**New Police Station**  
**Inuvik, NT**  
**Project Number: R.050563**  
**Addendum #2**  
**May 28, 2014**

**2.0 Architectural Addendum**

# Mechanical Addendum M-02

# Electrical Addendum E2

PARTIAL PRINT OF E2.02 - NEW DOOR

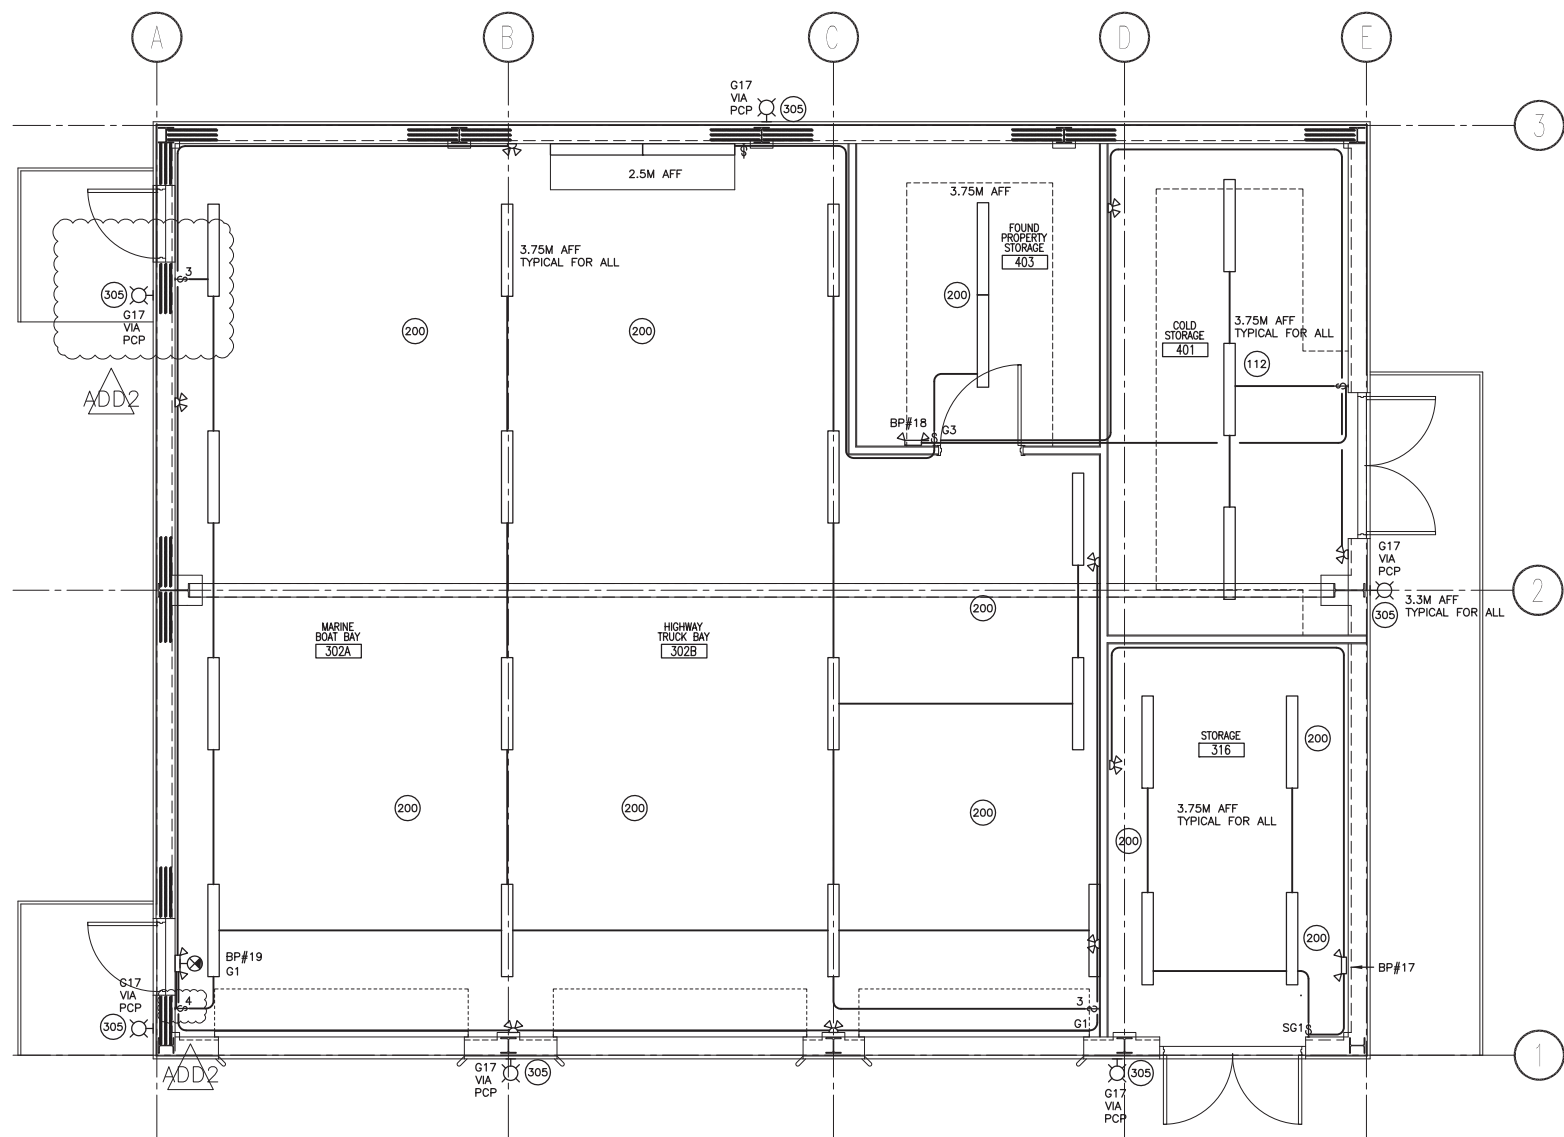
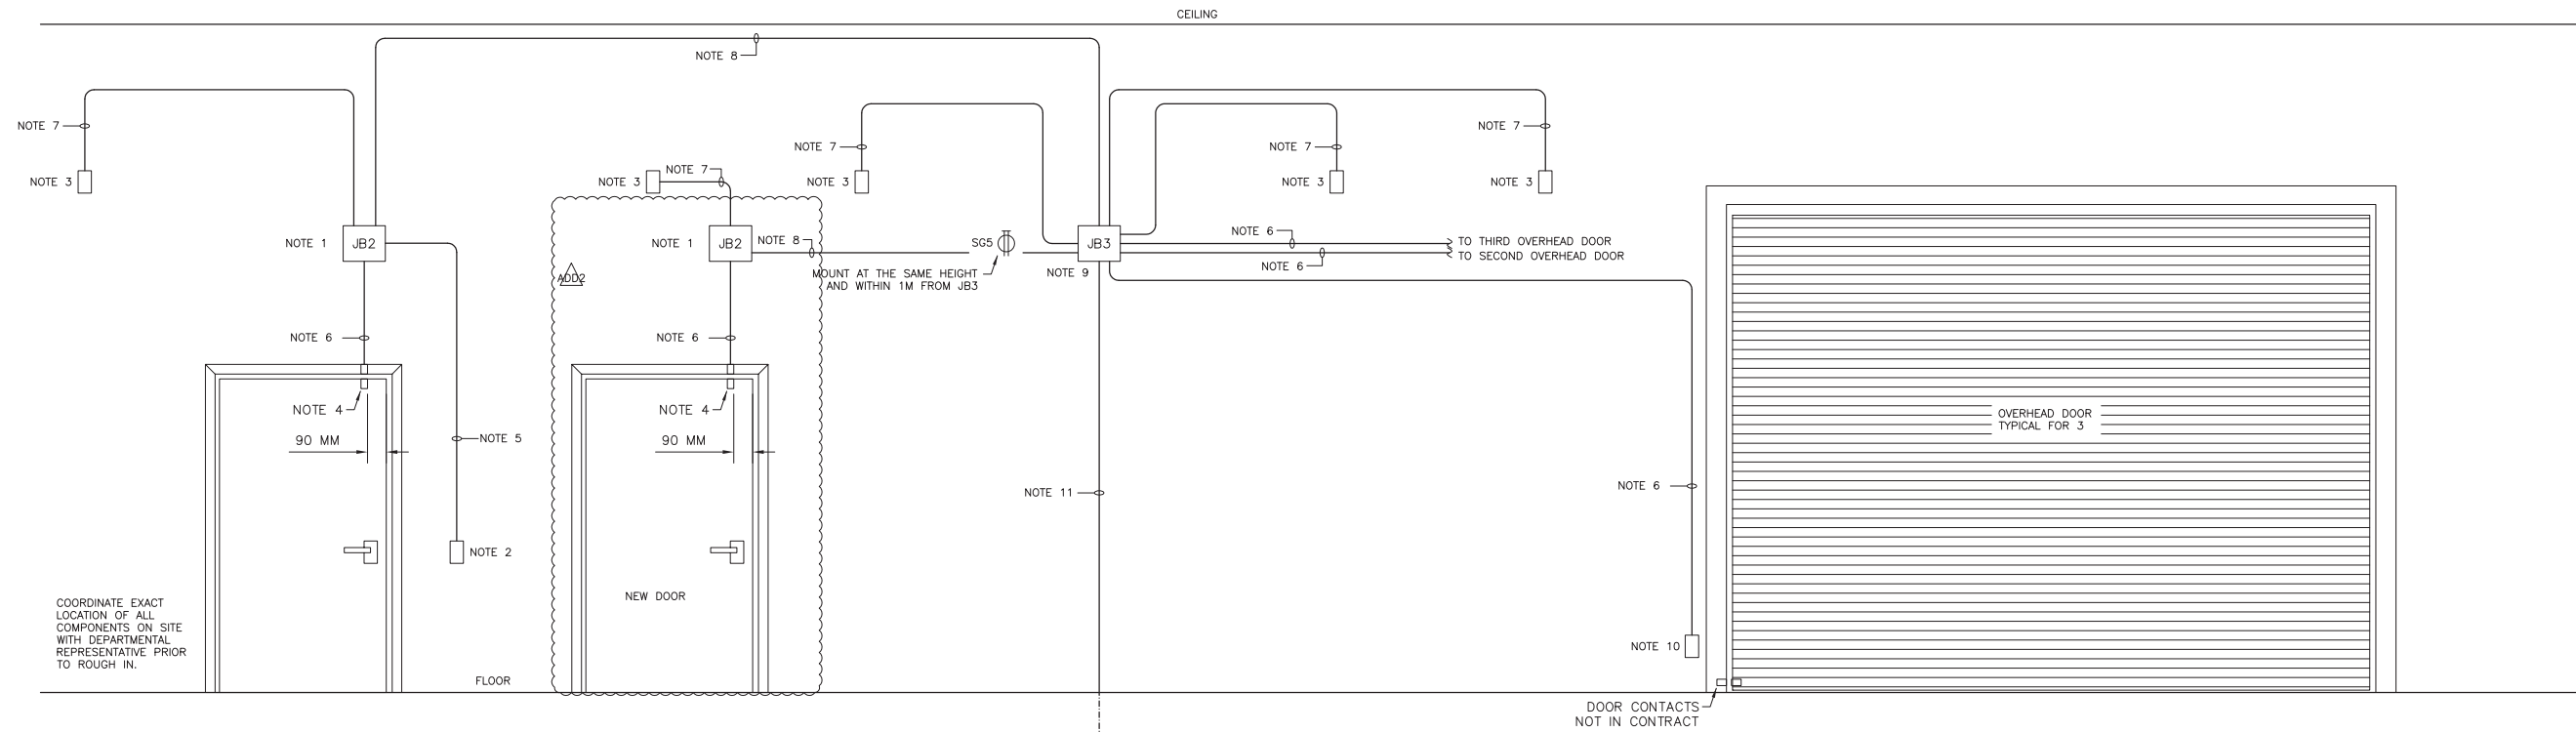
2. Drawing E2.01, Crawlspace Electrical plan:  
Replace the drawing with the attached revised copy of the same and bid accordingly.
3. Drawings E2.02 and E3.07, Outboard Garage Building Electrical Plans and intrusion alarm detail:  
Add a light switch by the new door as shown on the partial print of E2.02.  
Add a new door contact and junction box as shown on the partial prints of E2.02 and E3.07.

PARTIAL PRINT OF E2.03

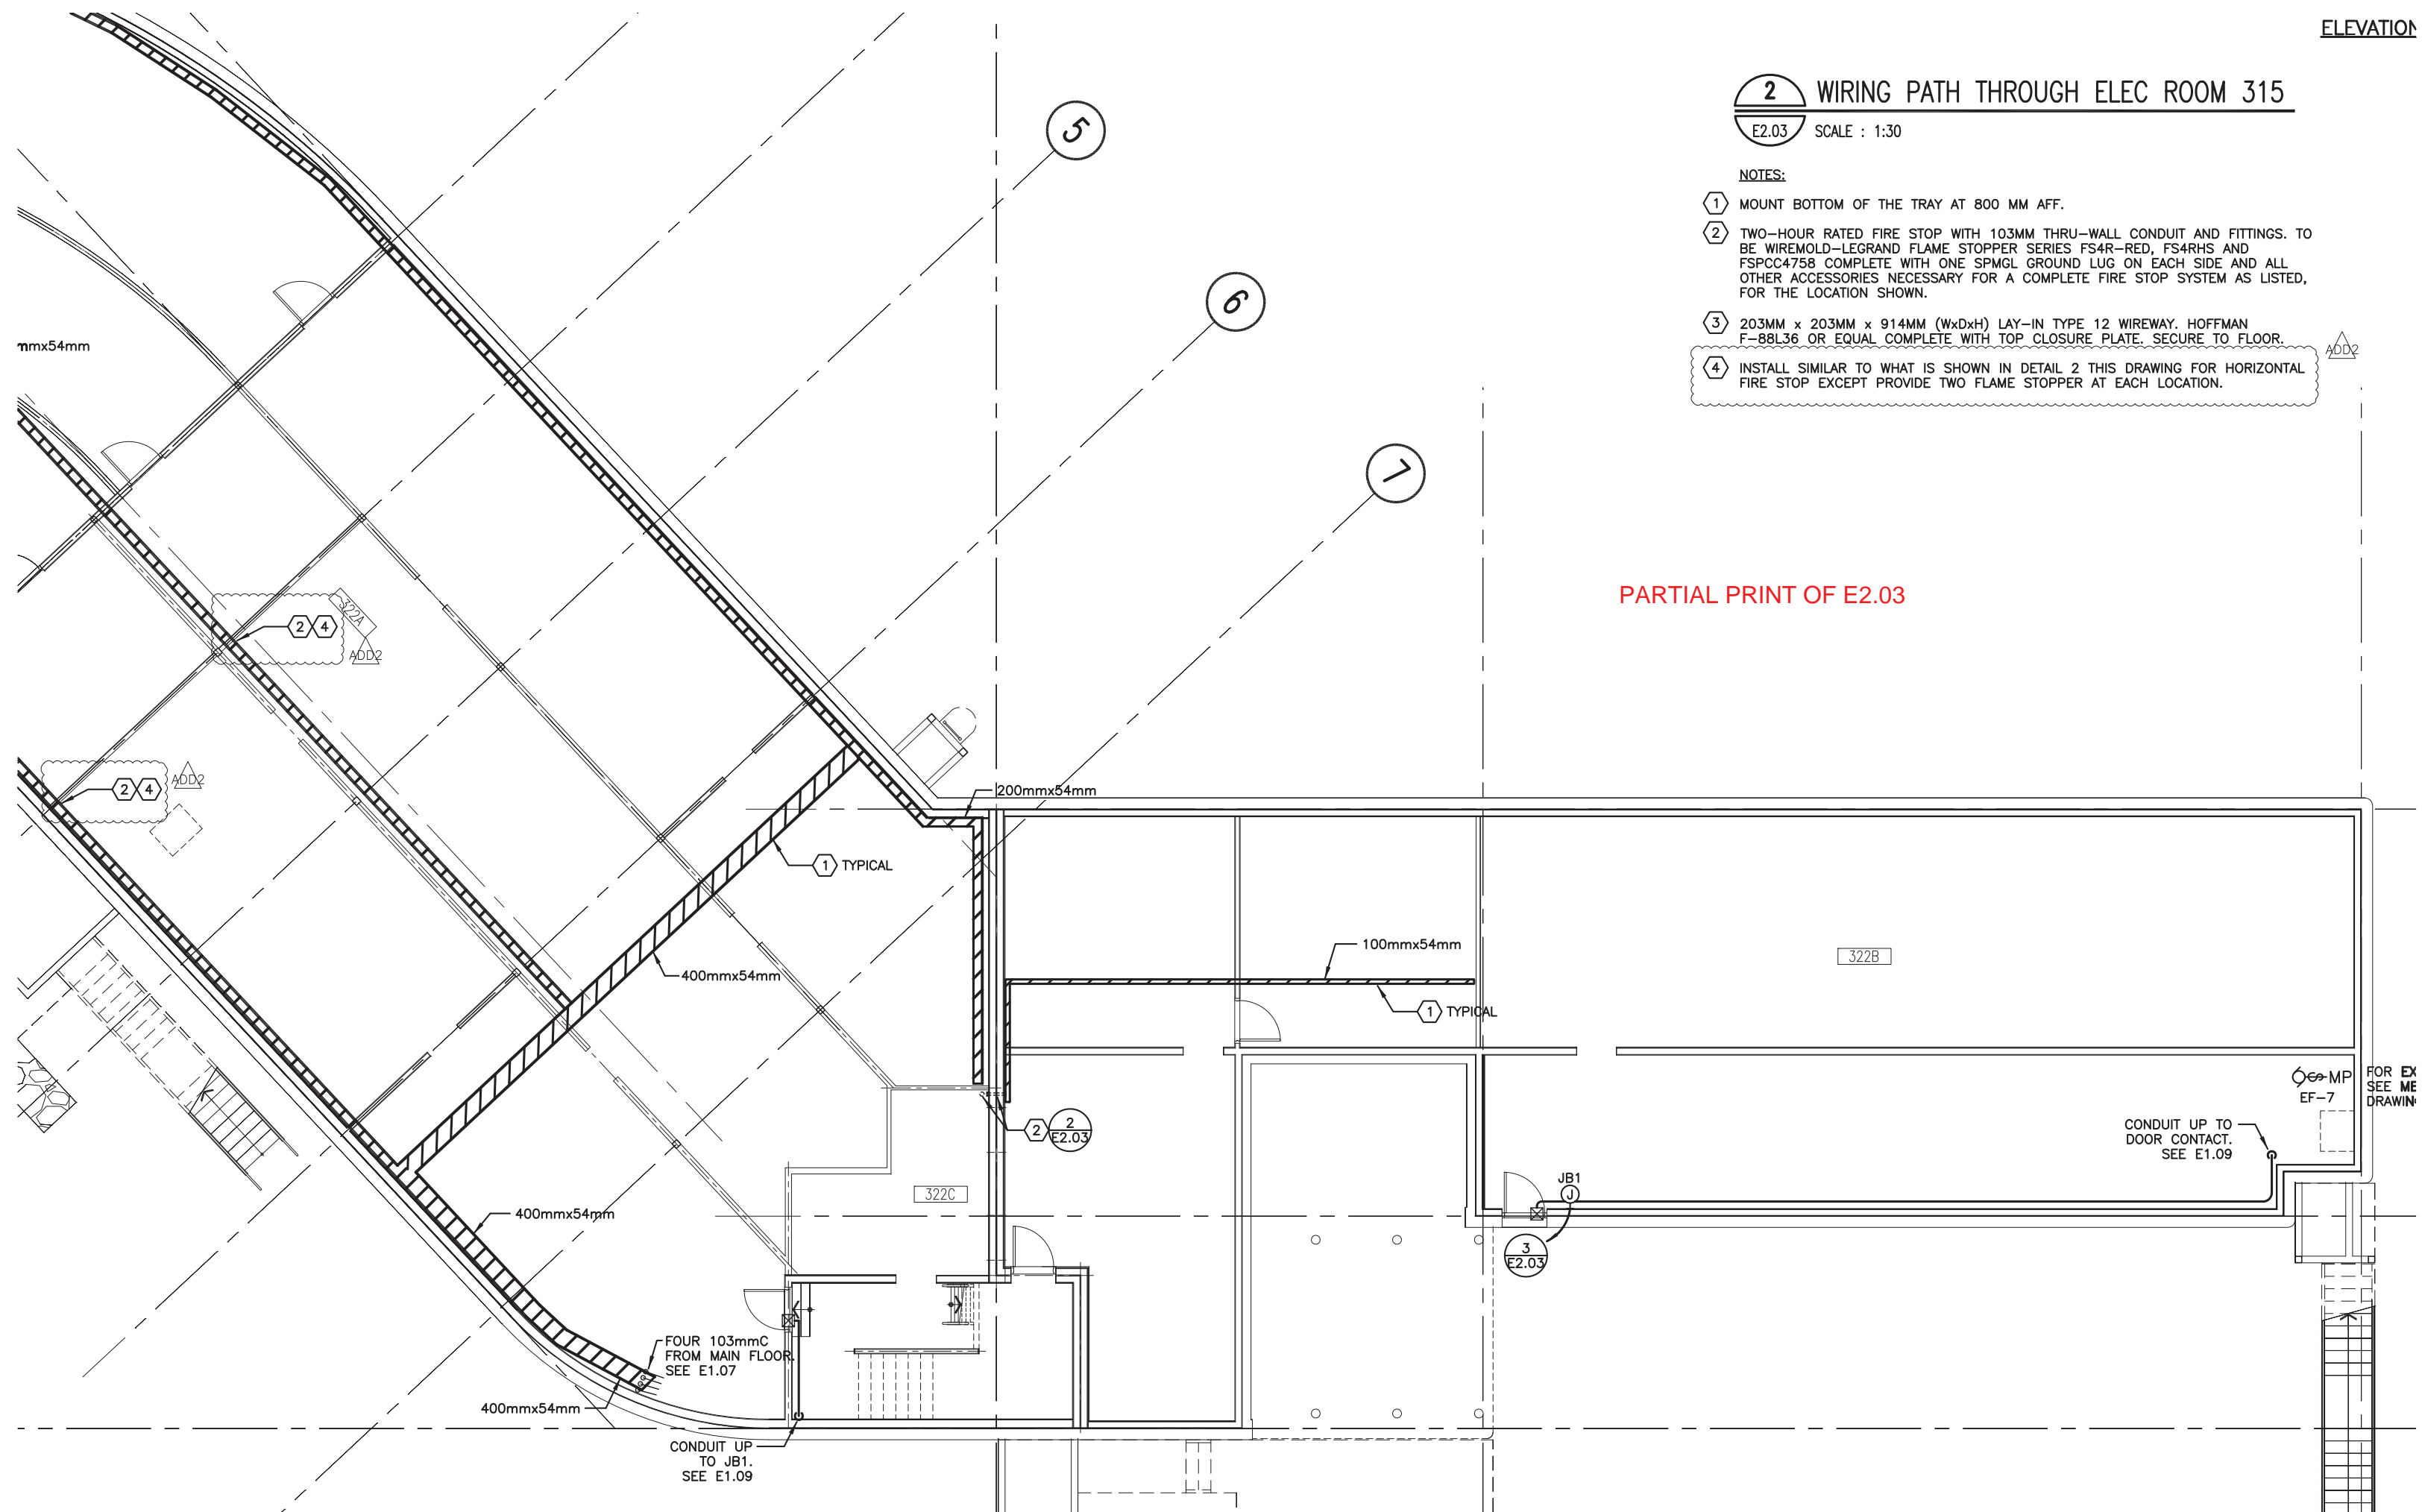
4. Drawing E2.03, Crawlspace Voice/Data Cable Tray layout and security Provisions Plan:  
Provide fire stop at fire separation penetration as shown on the attached partial print of E2.03.

- ① MOUNT BOTTOM OF THE TRAY AT 800 MM AFF.
- ② TWO-HOUR RATED FIRE STOP WITH 103MM THRU-WALL CONDUIT AND FITTINGS. TO BE WIREMOLD-LEGRAND FLAME STOPPER SERIES FS4R-RED, FS4RHS AND FSPCC4758 COMPLETE WITH ONE SPMGL GROUND LUG ON EACH SIDE AND ALL OTHER ACCESSORIES NECESSARY FOR A COMPLETE FIRE STOP SYSTEM AS LISTED, FOR THE LOCATION SHOWN.
- ③ 203MM x 203MM x 914MM (WxDxH) LAY-IN TYPE 12 WIREWAY. HOFFMAN F-88L36 OR EQUAL COMPLETE WITH TOP CLOSURE PLATE. SECURE TO FLOOR.
- ④ INSTALL SIMILAR TO WHAT IS SHOWN IN DETAIL 2 THIS DRAWING FOR HORIZONTAL FIRE STOP EXCEPT PROVIDE TWO FLAME STOPPER AT EACH LOCATION.
